ADDENDUM NO. 4

TO: PLANS AND SPECIFICATIONS FOR STATE OF MISSOURI

Renovate Mechanical / Electrical / Life-Safety / State Office Building
Jefferson State Office Building
205 Jefferson Street
Jefferson City, MO 65101
PROJECT NO. O1911-01

SHEET NUMBER:
FP3.1
 147 OF 244 SHEETS

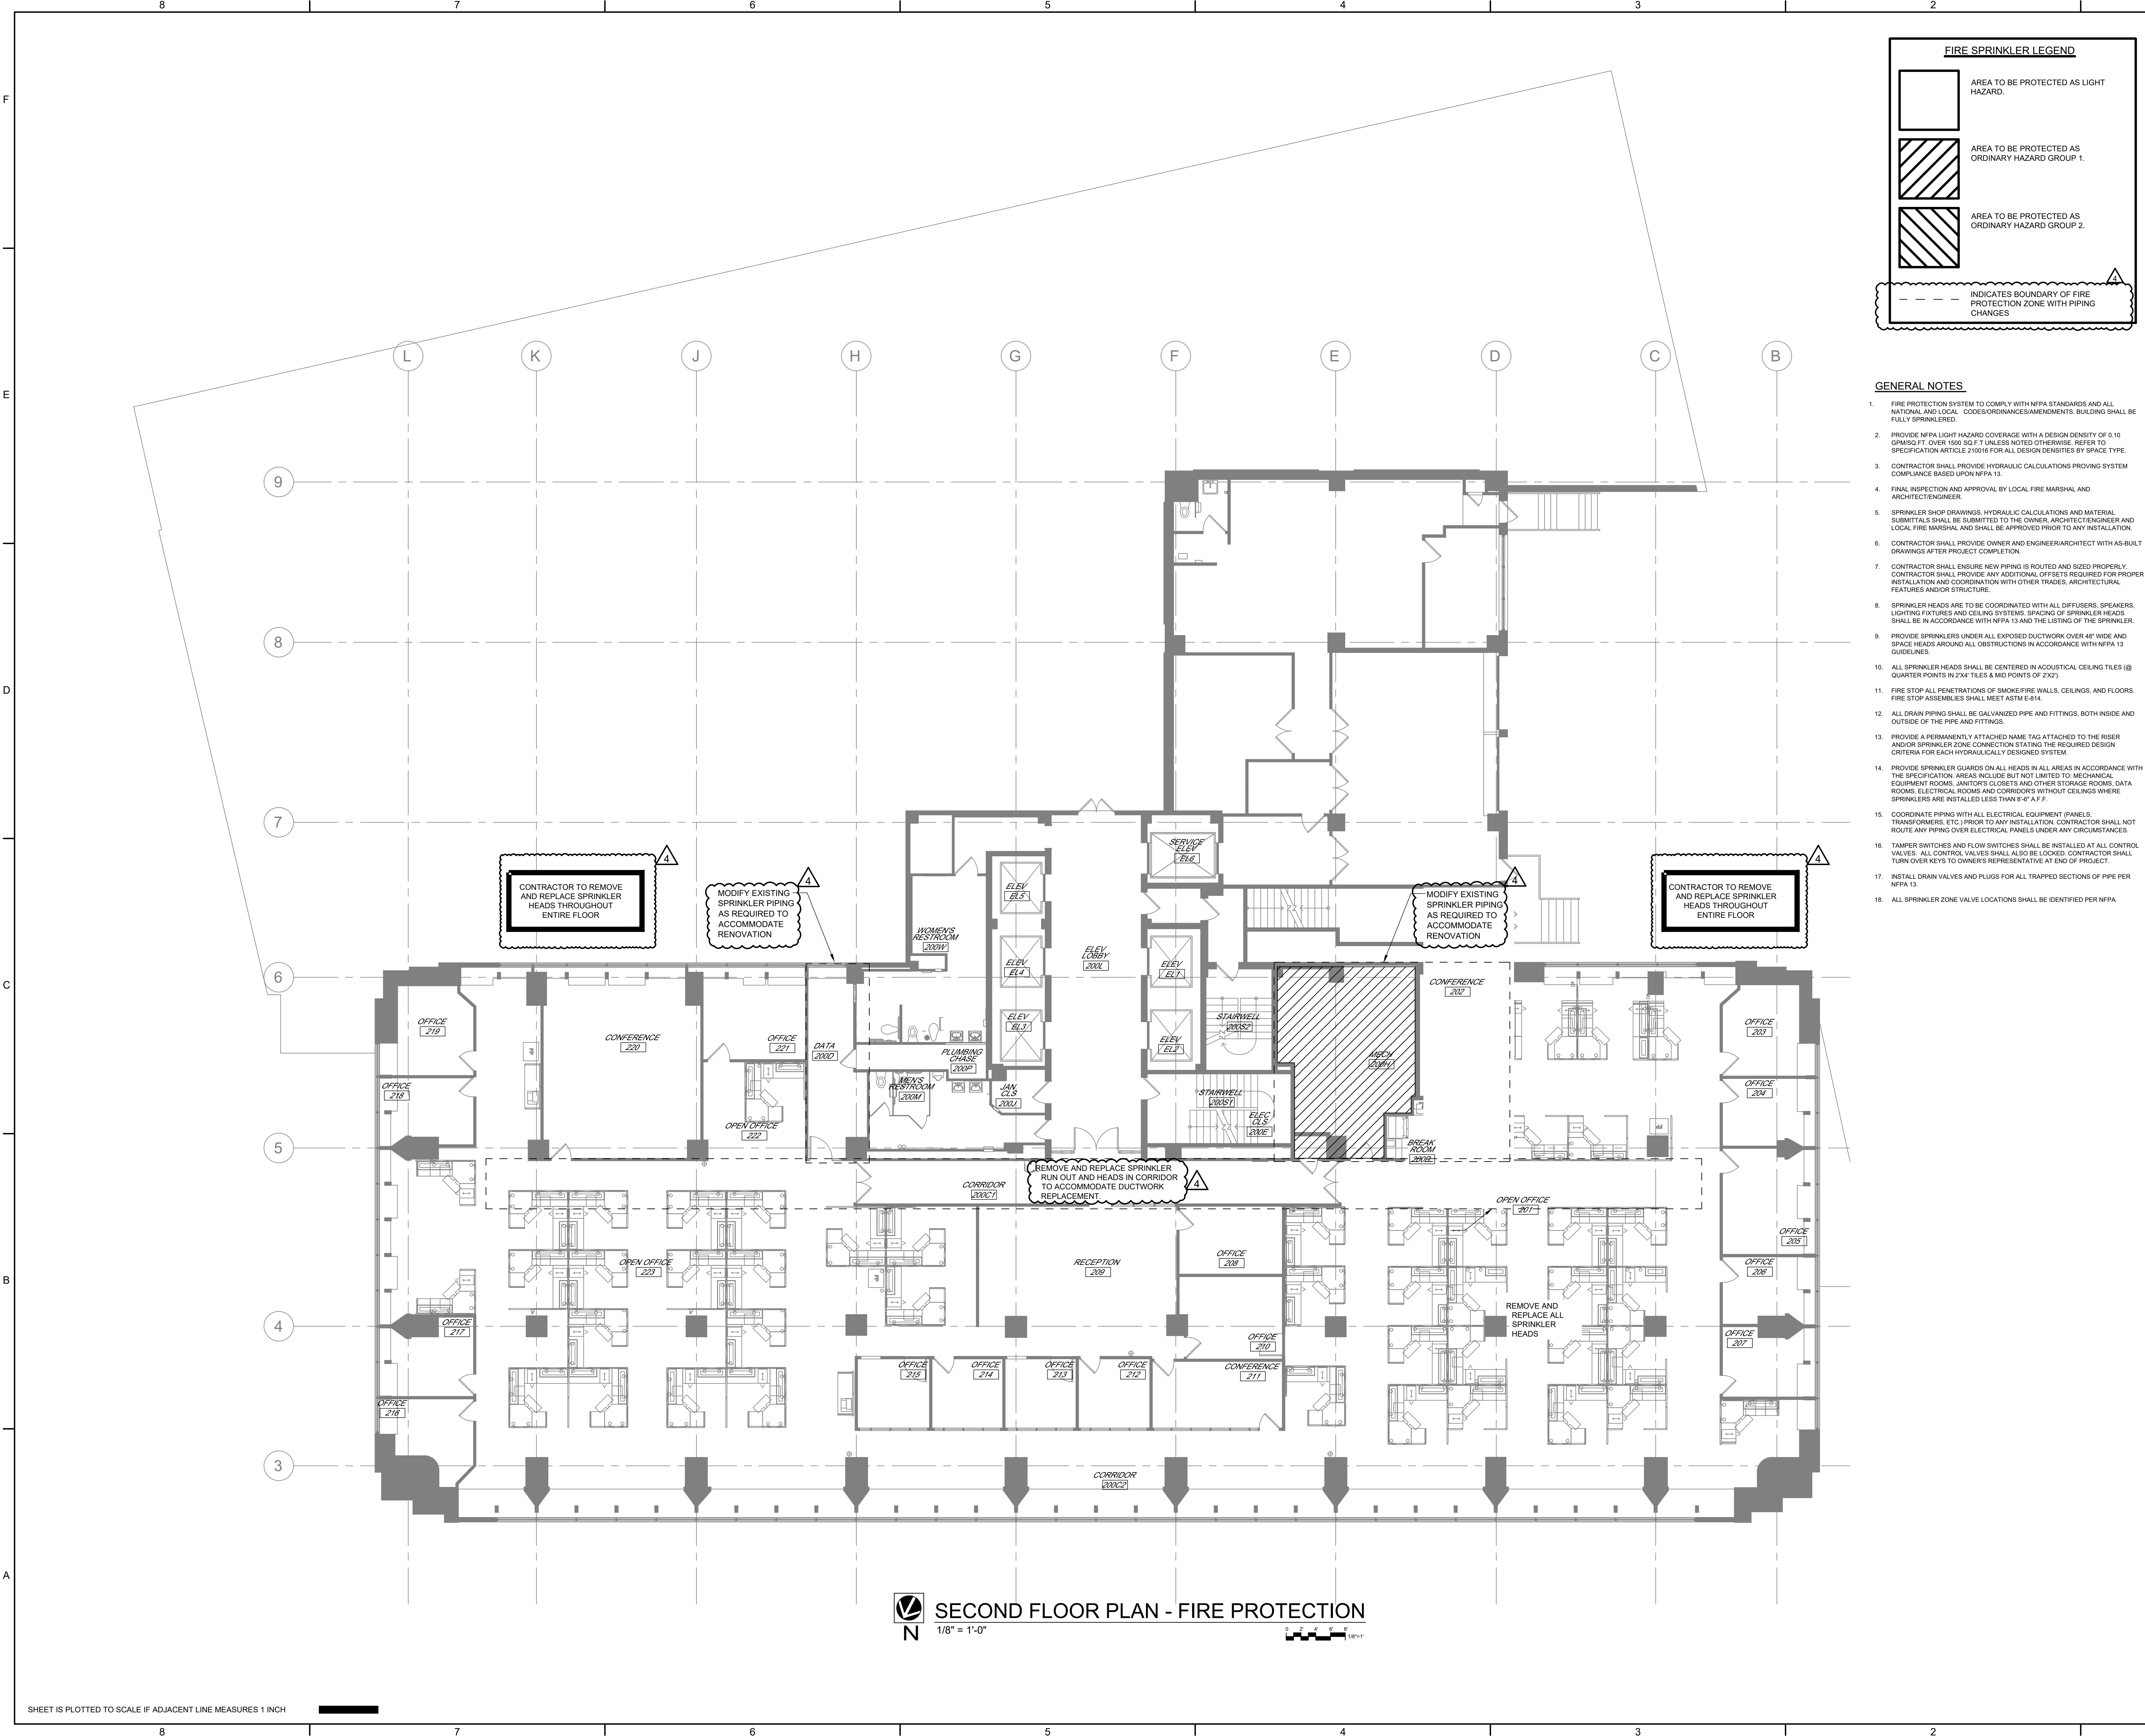
18. Drawing M6.4:
 - a. **ADDED** – DX Coil Schedule.
 1. Drawings: FP3.1, FP3.2, FP3.3, FP3.4, FP3.5, FP 3.6, FP3.7, FP3.8, FP3.9, FP3.10, FP3.11, FP3.12, FP3.13

- a. **ADDED** – Replace Sprinkler heads throughout entire floor.
